## Contract Change Order # 3

Project Name: <u>LLWWTP Headwords Improvements</u>	Project Number: <u>165420/165423</u>
Project Location: <u>Lynn Lane Waste Water Treatment Plant</u>	Date of Application: <u>Monday, February 25, 2019</u>
Contractor: <u>Crossland Heavy Contractors</u>	Submitted By: <u>Jason Smith</u>

### Summary of Change in Scope of Work

FIGURE  
RFI 046

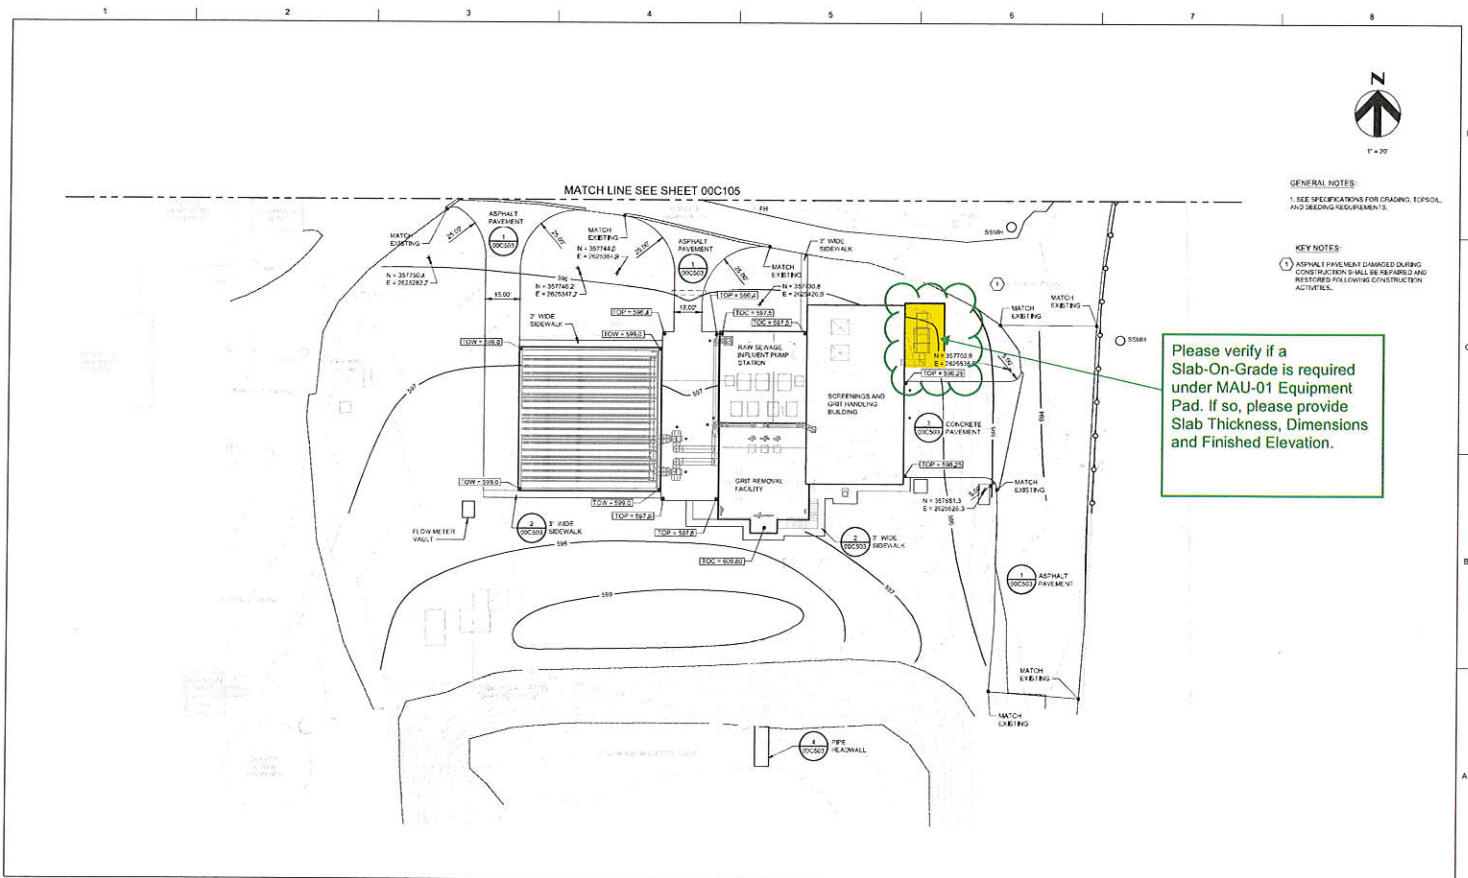
Please verify if a Slab-On-Grade is required under MAU-01 Equipment Pad. If so, please provide Slab Thickness, Dimensions and Finished Elevation.

<b>Response:</b>
<p>Area pad for MAU unit shall be per Detail 1/00S106. Housekeeping pad for MAU shall be per Detail 2/00S106. See attached figure for clarification including spot elevations (TOP = top of pavement) and pad limits.</p>
<p><b>Answered by: Todd Townsend, Brian Perlberg</b></p>
<p><b>Date Answered: October 16, 2018</b></p>

FILENAME: 1002644\_01\_STRUCTURAL SHEET 10A204

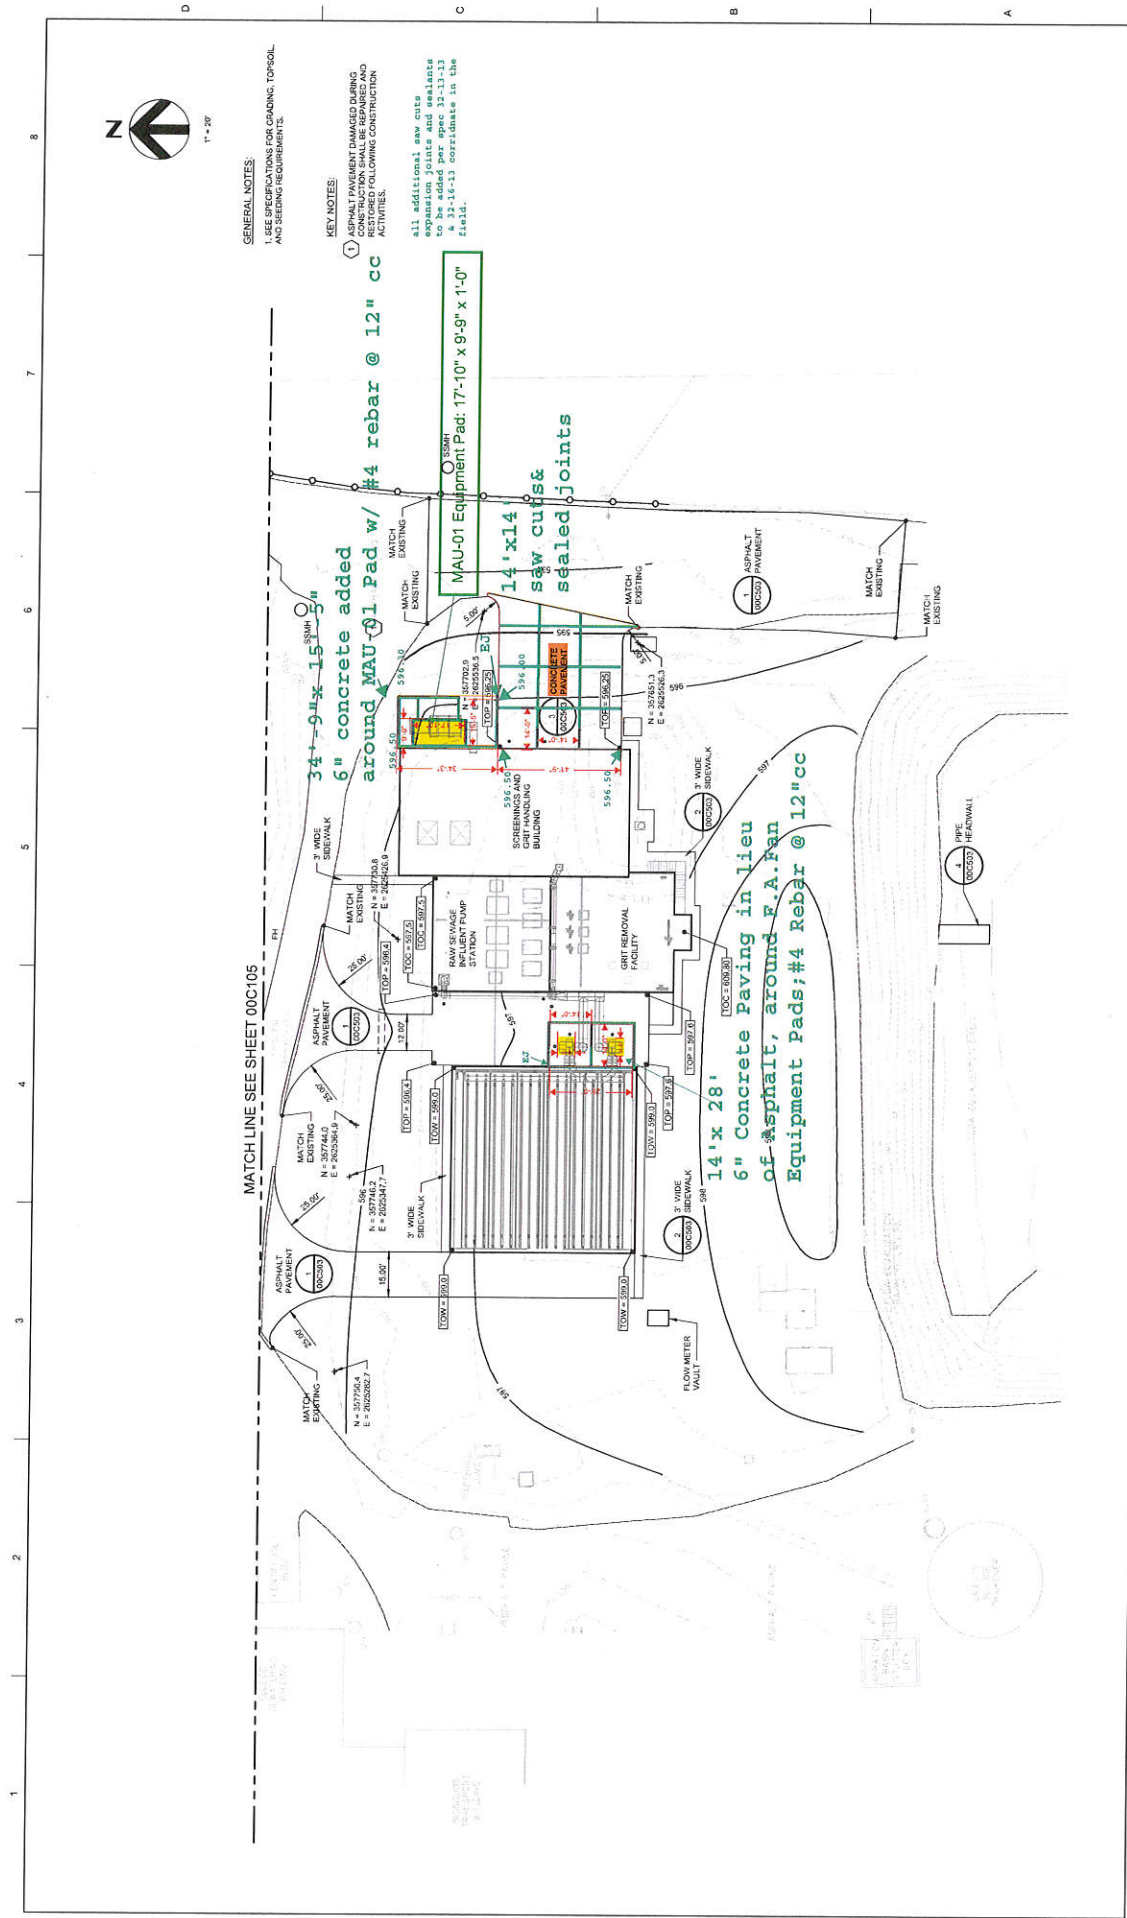
Per Section Marker 10A204 referenced here, No Concrete Slab or Paving is indicated in this area on Plan Sheet 10A203, please advise.

SHEET  
40S101

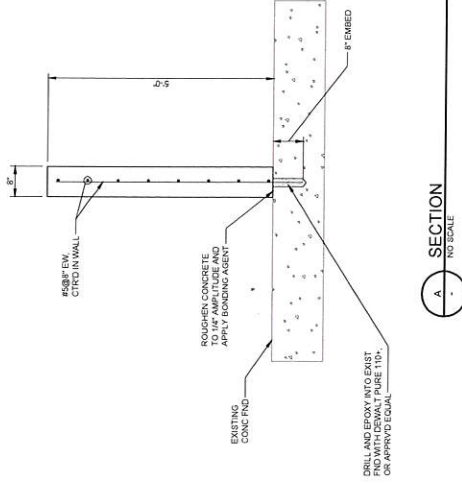
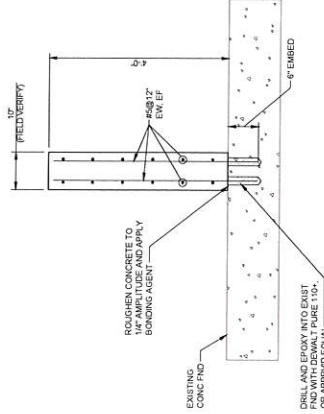
Per the request of the Utilities Department, the contractor is to install (4) concrete radial walls within the existing aeration basins. This request is being performed during the cleaning operations within the aeration basins already being performed by this contract. The

- 3) contractor shall follow the provided construction drawings by HDR for these wall sections. The below costs are a summary of the costs associated to install the associated walls as a complete in place product.

Description of Work: Placement of four (4) Radius Concrete Walls in the Aeration Basins.
